Planning Commission Meeting Packet

January 14, 2014

a. Public Hearing - SP 13-03 Sherwood Industrial Park, Phase II
(Michelle Miller)

At the hearing on November 26, 2013, the Planning Commission continued the Sherwood Industrial Park (SP 13-03) site plan review until January 14, 2014. The applicant requested a continuance in order to submit a revised plan set with building elevations that addressed the alternative industrial design standards found in the Sherwood Zoning and Development Code (SZDC) § 16.90.030.D.8b. (Alternative Industrial Design Criteria).

SHEET TITLE:
**ELEVATIONS -
BUILDING THREE**

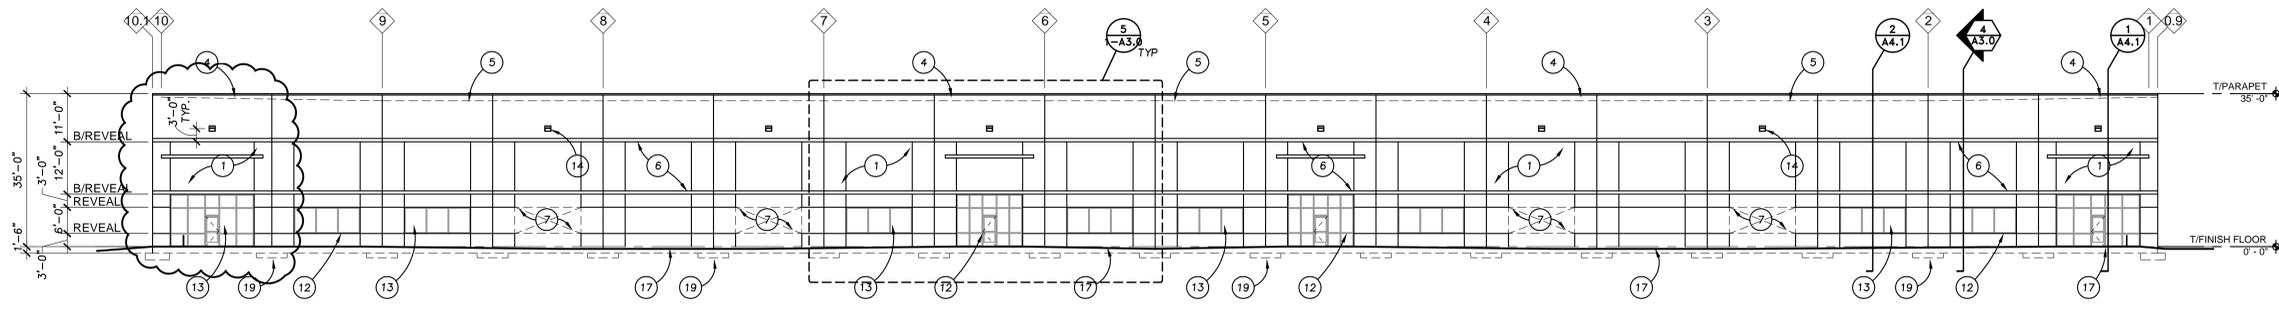
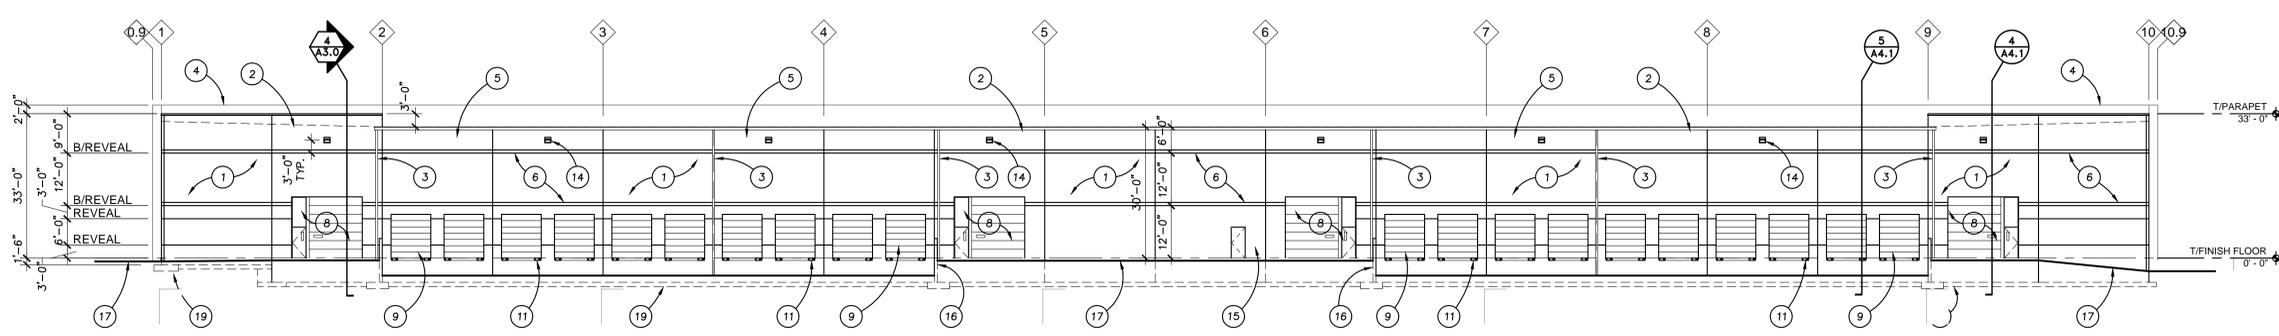
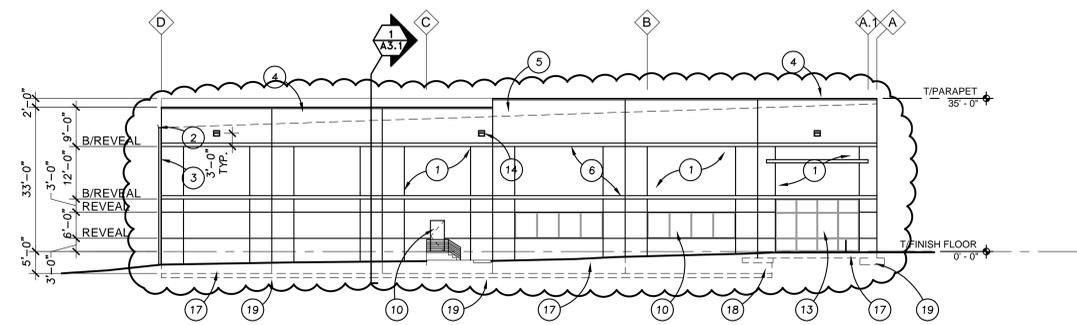
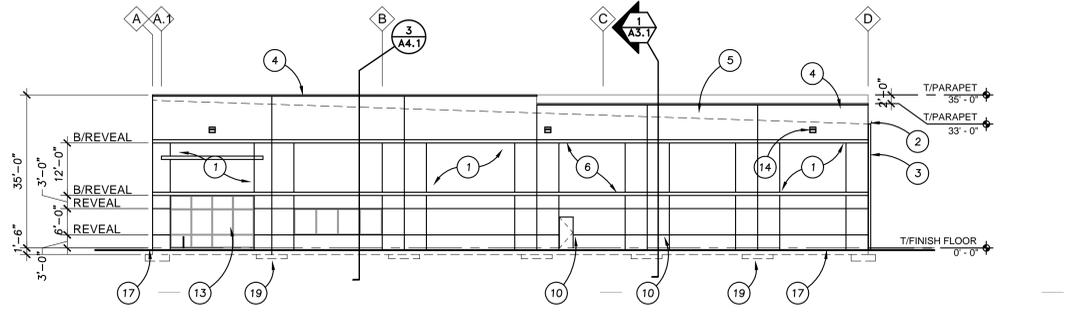
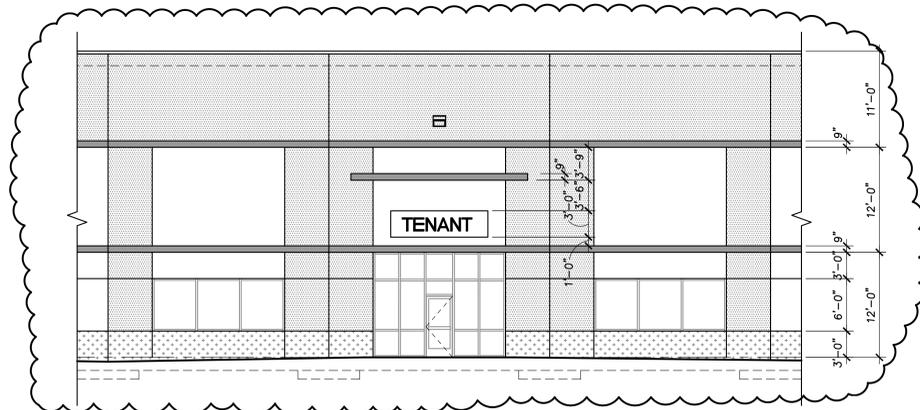
At the last hearing, the Planning Commission raised concerns that the original submittal did not meet all of the Alternative Industrial Design criteria that were necessary to grant approval of the project. The Commission discussed that they would likely agree and be able to make findings that the applicant met conditions § 16.90.030.D.8b (1-4) and (7) but the buildings would not meet Alternative Design Criteria (5) and (6). The applicant decided that they would like to reassess their building design in order to fully comply with these criteria.

The applicant has proposed adding glazing to the street facing side, relocating an entryway, and providing a recessed storefront entry, that better defines the corners of the buildings. The applicant has added several architectural reveals in the concrete panels, and vertical

paint accents to increase interest along the street facing side of the buildings. The applicant has added landscaping and new "pop outs." **The top of the wall panels have been increased and varied to break up the buildings' mass.**

Building 4, the entry of Building 3 has been relocated to the corner, providing a recessed storefront entry that wraps around the corner of both buildings and additional windows have been added to each building to increase the amount of glazing on that face to better align with City of Sherwood standards. The number of architectural reveals in the concrete panels has been increased, and vertical paint accents have been added, to provide additional texture and visual interest on the north face of both buildings. The paint scheme has been modified to define vertical bands at panel edges to reduce the size of any singular color field. Additional reveals have been added, along with paint striping above the entries, to create an accent to enhance and define a tenant signage area. These elements have been added to enhance the appearance of the proposed buildings from Century Drive.

In addition to increased glazing on both of the buildings’ north walls that front Century Drive, the revised buildings’ north façades are broken up by “pop outs” of the office entry panel two feet beyond the main face of the building. This “pop out” feature will differentiate office entry areas from the rest of the building and effectively reduce the length of the north side of both buildings. The landscaping width between Century Drive and the proposed buildings has been increased by two feet to provide area for additional shrubs to soften the buildings. The top of the wall panels has been modified to provide differing heights to the façade in order to break up the visual mass of the building. Lastly, a revised landscaping plan incorporates evergreen trees adjacent to the building to ensure a landscape buffer throughout all seasons. The tree canopy and shrub counts, in addition to the total landscape area provided, exceed City of Sherwood minimum standards.
